Proposal for amendment to ECE/TRANS/WP.29/GRSG/2024/12

(Vulnerable Road Users in Front and Side Close Proximity)

Submitted by the expert from Japan

Figure 1
Example for the measurement by maximum variation

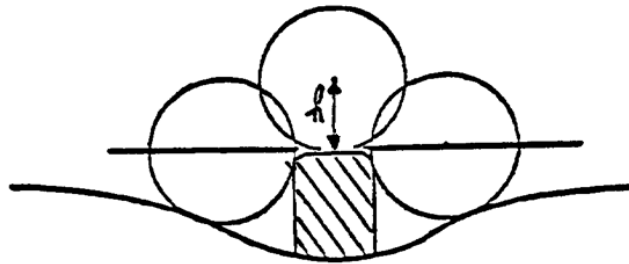
6.1.3.3.2. If the dimension of the projection of a component which is mounted on a surface other than convex cannot be determined by simple measurement, it shall be determined by the maximum variation of the distance of the centre of a 100 mm diameter sphere from the nominal line of the panel when the sphere is moved over and is in constant contact with that component.

Figure 1 shows an example of the use of this procedure.

The addition of impact safety requirements for mirrors copied from UN Regulation No.46 which reflects the latest amendment (GRSG-126-24r1) and exempt the devices approved by UN Regulation No. 26 or No. 61.

Figure 2
Dimensions of the Test Rig and the Special Design
 (in millimeters)

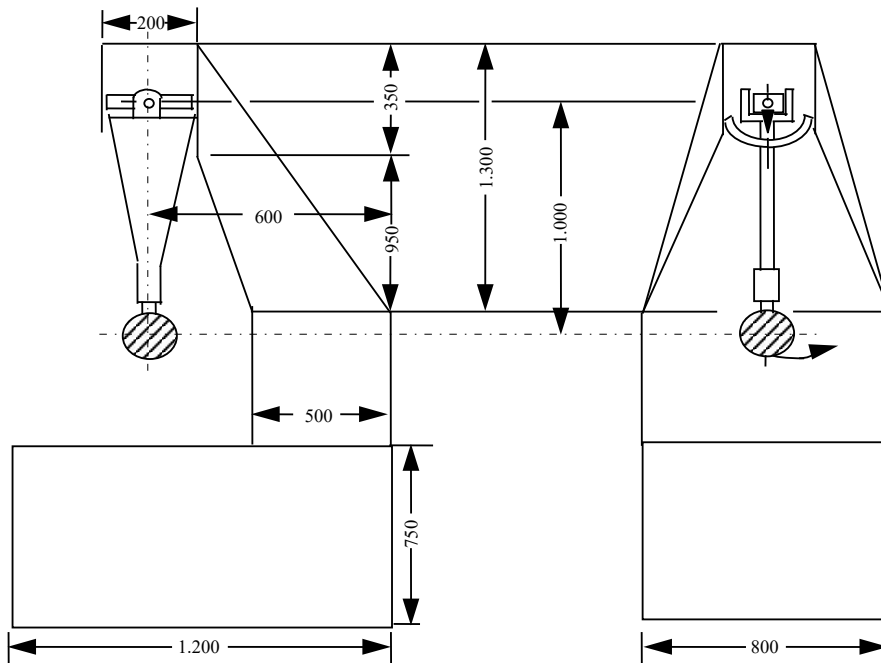
Figure 2 below gives the dimensions (in mm) of the test rig and the special design specifications:

Figure 3
Example of Mirror Bending-Test Rig

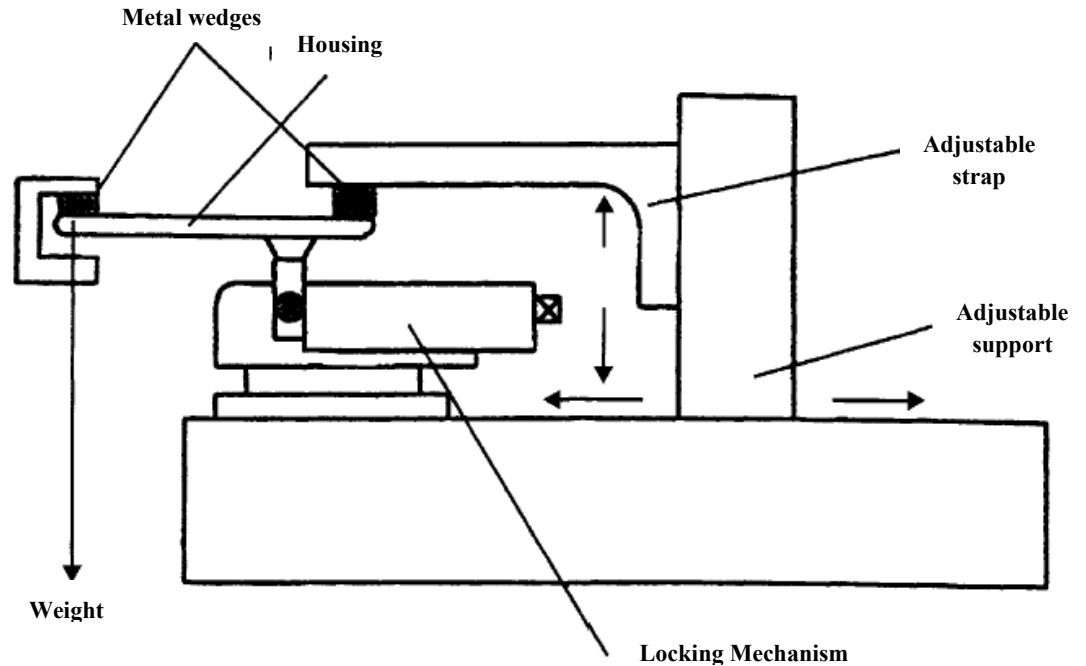
At the other end, a stop identical to the one described above is placed on the housing so that the specified test load can be applied to it (Figure 3).

The end of the housing opposite to that where the force is exerted may be locked rather than held in position as shown in Figure 3.

Figure 4
Monocular Fields
(Direct vision case)

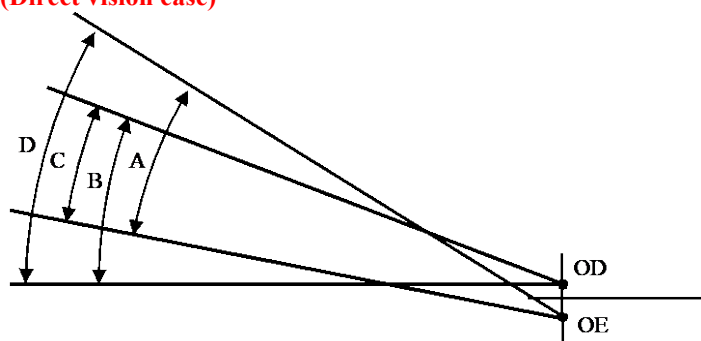
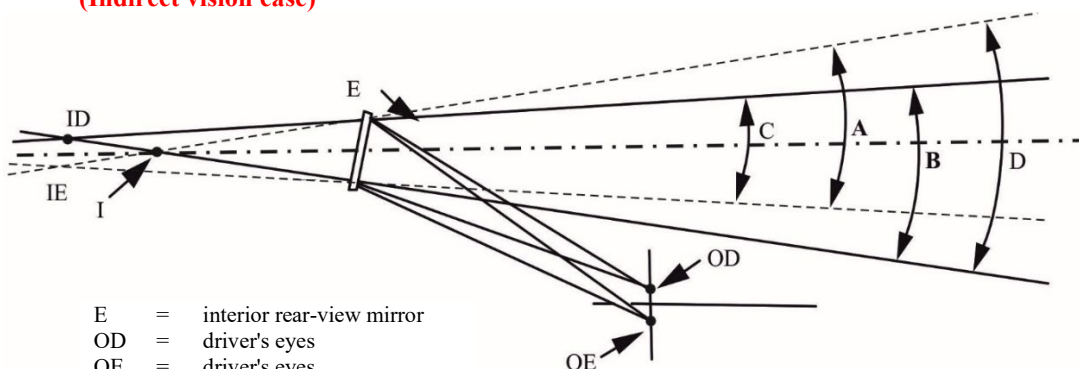
"12.2. "Ambinocular vision" means the total field of vision obtained by the superimposition of the monocular fields of the right eye and the left eye (see Figure 4 below).

Figure was copied from Regulation No.46. It was for indirect vision only. "Ambinocular vision" is for both direct and indirect vision. To prevent misinterpretation, direct vision case figure was added.

Figure 5
Examples of Designated Area of Each Means (Right-Handed Drive Case)

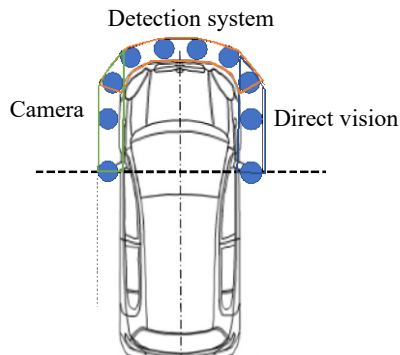
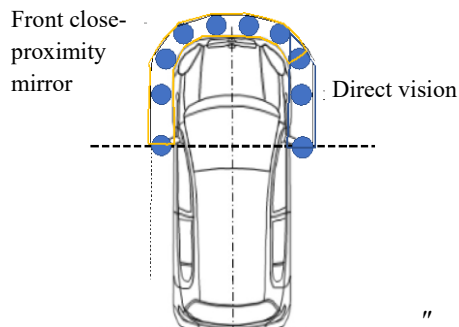
Overlaps of designated areas by different means (see examples in Figure 5) shall be permitted.

Reorganized between two paragraphs 15.1 and 15.2 for misunderstanding and for clear descriptions. The figures on pole location at the centre of the side mirror were updated to avoid misinterpretation.

Figure 6
Close-Proximity Front and Lateral Sides View Field of Vision

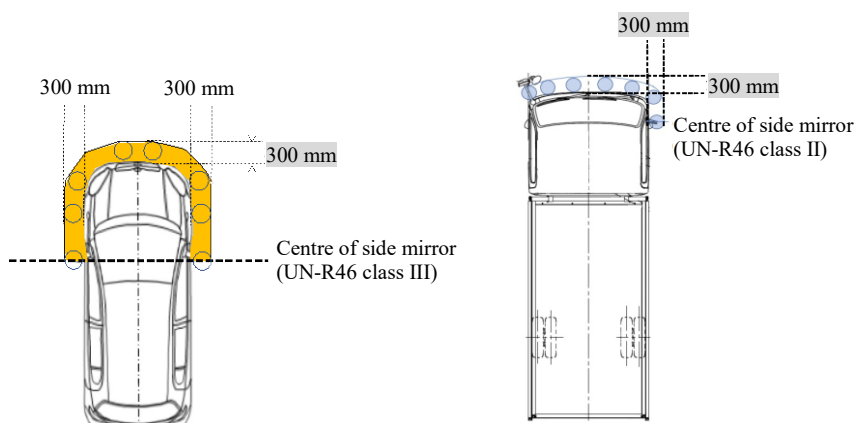
Paragraph 15.2., delete Figure 2 and amend to read:

The field of vision (see Figure 2 6 below) shall be bounded by the following planes:

- (a) A **longitudinal** ~~transverse~~ vertical plane passing through a point 300 mm from the contour of the sides of the vehicle;

- (b) A transverse ~~vertical~~ **horizontal** plane passing through a point 300 mm from the contour of the front of the vehicle;
- (c) Areas ahead of the centre of the side mirrors on the driver's seat side and the passenger seat side. In the case of the vehicle that equipped with CMS that comply UN Regulation No. 46, 04 Series of amendments, the manufacturer shall consider the same vehicle equipped with side mirrors or to use the centre of Class III or II CMS camera lens instead of the centre of the side mirrors.

Figure 7
Example for the Measurement by Maximum Variation

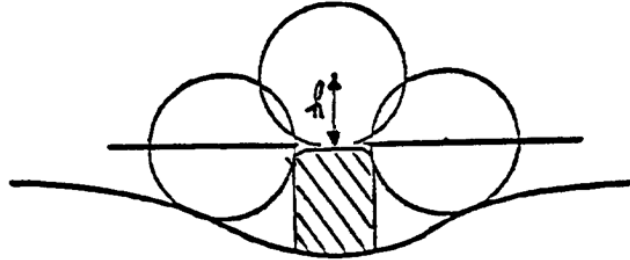
15.4.3.2.2. If the dimension of the projection of a component which is mounted on a surface other than convex cannot be determined by simple measurement, it shall be determined by the maximum variation of the distance of the centre of a 100 mm diameter sphere from the nominal line of the panel

Figure 7 shows an example of the use of this procedure.

Addition of impact safety requirements for FLVCS and Detection system same concept as mirror (6.1.3.). These requirements are modified for consistency with CMS requirements of Regulation No.46 Paragraph 6.2.

Arrangement of Approval Mark for a Device for Means of Front and Lateral Vision

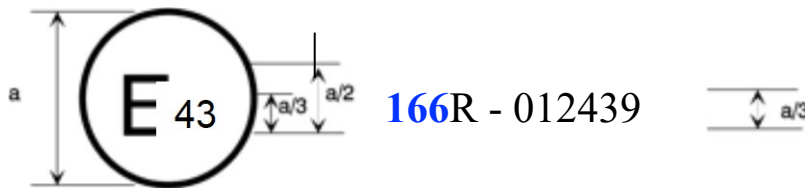
The above approval mark affixed to a device for means of front and lateral vision indicates that the device is a main close-proximity front and lateral view device, which has been approved in Japan (E 43) pursuant to UN Regulation No. 166 and under approval number ~~002439~~ **012439**. The first two digits of the approval number indicate that **UN Regulation No.166 already included the 01 series of amendments when the approval was granted in accordance with the requirements of UN Regulation No. 166 in its original form.** ..."

Corrected to fit the 01 series of amendment. **Regulation number replaced XXX to 166 in the figure.**

Figure 2
Test Object Locations

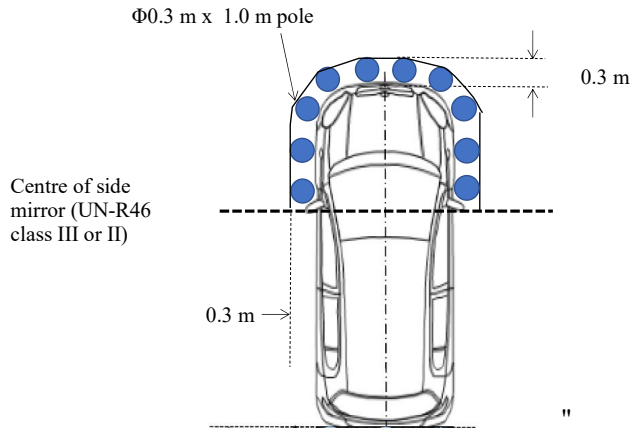
- "1.2. The test object shall be in contact with the vehicle's front and lateral side from the centre of passenger side mirror to driver's side mirror shall be seen in the close-proximity front and lateral view field of vision. In the case of the vehicle that

equipped with CMS that comply UN Regulation No. 46, 04 Series of amendments, the manufacturer shall consider the same vehicle equipped with side mirrors or to use centres of Class III or II CMS camera lens instead of the centres of the side mirrors.

Add the description for the Class II mirror in the figure.

Necessity of Pendulum Impact Test

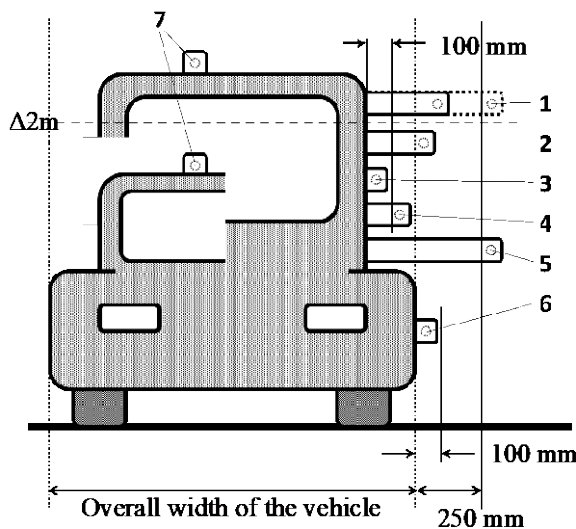
PENDULUM IMPACT TEST	
<u>Device for indirect vision (mirrors)</u>	
1	NO TEST
2	COMPULSORY
3	NO TEST
4	NO TEST
5	not permitted
6	NO TEST
<u>Device for indirect vision (FLVCS)</u>	
7	NO TEST

Reflects the latest amendment of UN Regulation No. 46 (GRSG-126-24r1). **Figure was updated due to some lines were missing at the copied from GRSG-126-24r1.**
